Questions about the IEEE 802 Architecture

Roger Marks (EthAirNet Associates; Huawei)

2 December 2021

Figure 3—IEEE 802 RM for end stations

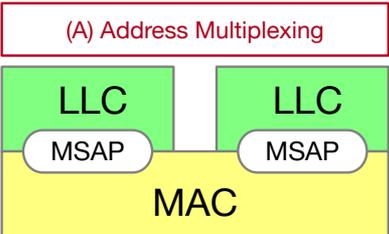
Can two LLC entities communicate (e.g. share control information)?

How does the application express QoS requests?
 How does LLC arbitrate when multiple upper layers have data for the LSAP?

What are the characteristics of the Link Layer service provided to the Link Layer client at the LSAP, analogous to the LLC specification in IEEE Std 802.2?
 What parameters are passed?
 What are the allowed frame formats? Which formats are forbidden or blocked?

What are the functions of the LLC?
 How are the parsing rules used to identify the service parameters (from LSAP and from MSAP)?

What are the allowed frame formats?
 How is the MSAP characterized by MAC address; e.g., can an MSAP have multiple MAC addresses; e.g. multicast addresses).

Does the MAC handle this? Are there arbitration issues when both LLCs send data to the MAC?

Do the MSAP and Optional MSAP allow configurations (A), (B), and (C)? The figure seems to suggest (A). IEEE 802 says "MAC sublayer provides one or more MAC service access points (MSAPs) as interfaces to the LLC sublayer in an end station"; this could be (A) or (B). Is (B) allowed? Do we need (B)? Is Link Aggregation (C) within the architecture?

Figure 6—LLC sublayer in 802 RM

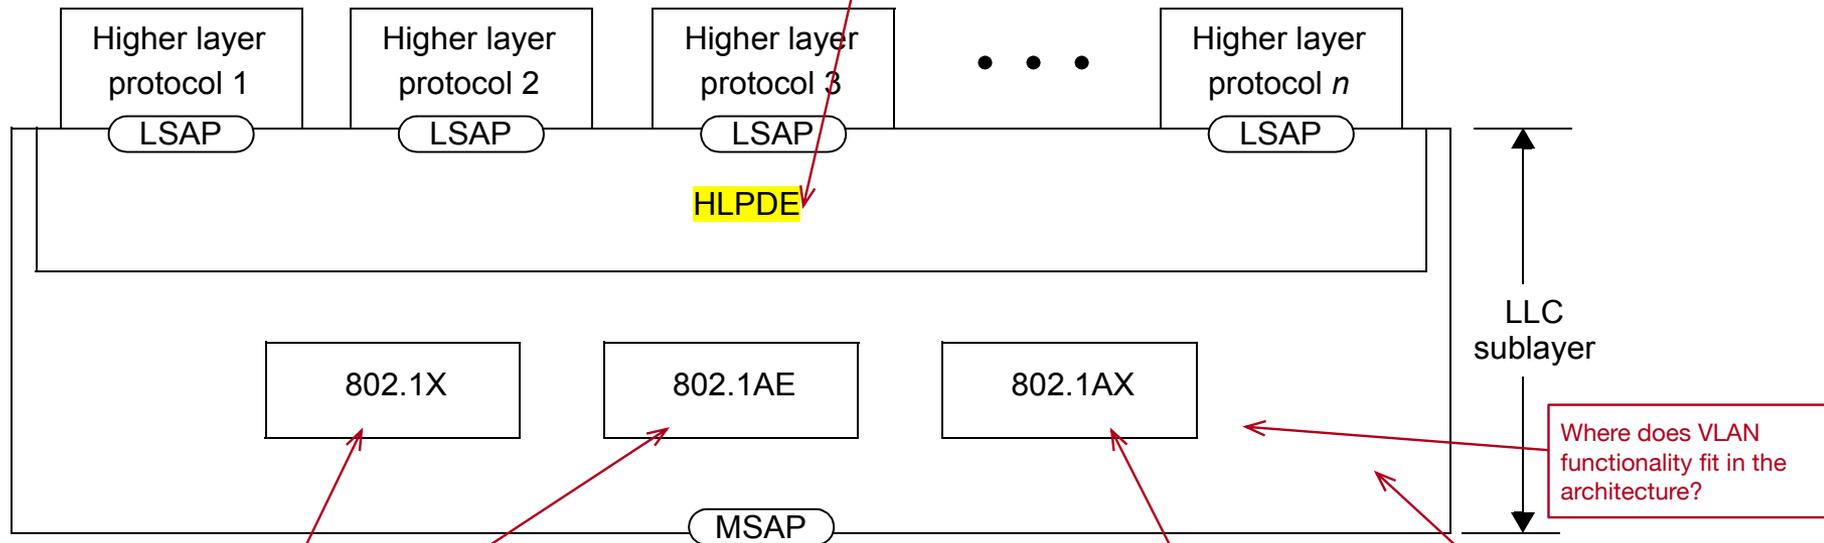
How do 802.1X Port-Based Network Access Control and 802.1AE MAC Security fit into the sublayered architecture?

How does 802.1AX Link Aggregation fit into the architecture? Does this imply multiple MSAPs (to multiple MAC entities) below an LSAP (C), even though only one is shown?

What's else is missing? Other methods using end-station tags; e.g.:
 •802.1CB Redundancy-tag for Frame Replication and Elimination for Reliability (FRER)
 •CN-tag for congestion notification

Where does VLAN functionality fit in the architecture?

Figure 6-6—Two back-to-back EISS Multiplex Entities

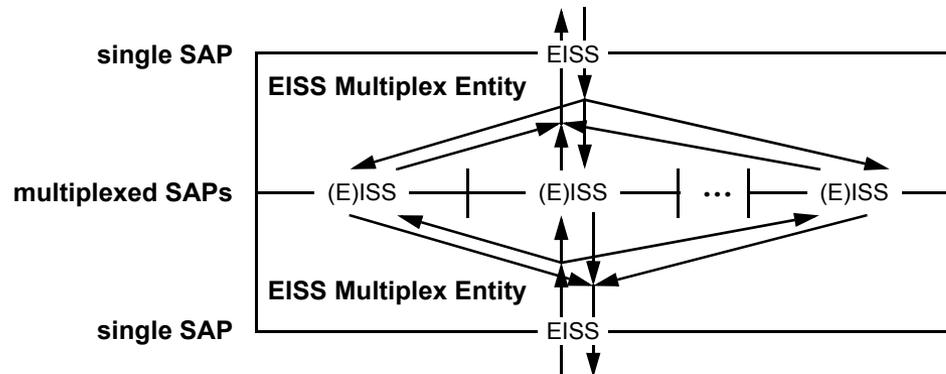
IEEE Std 802 need not detail bridge architecture, but some tags are used in end stations. Sometimes the architecture is unclear.

Figure C-2—Protocol stack for End System B in Figure C-1

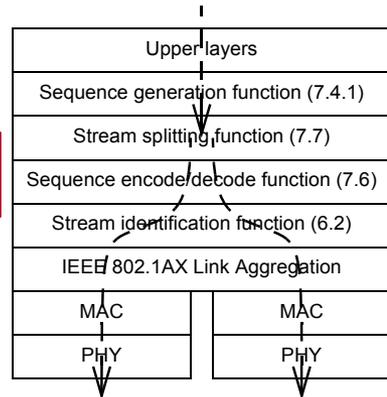
In the 802 architecture, everything between MAC and upper layers is LLC, so this is all within LLC.

Figure C-3—Protocol stack for End System G in Figure C-1 and Figure C-4

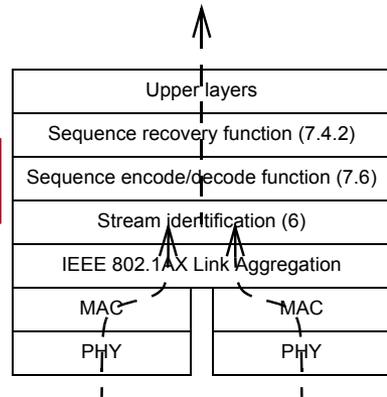
In the 802 architecture, everything between MAC and upper layers is LLC, so this is all within LLC.
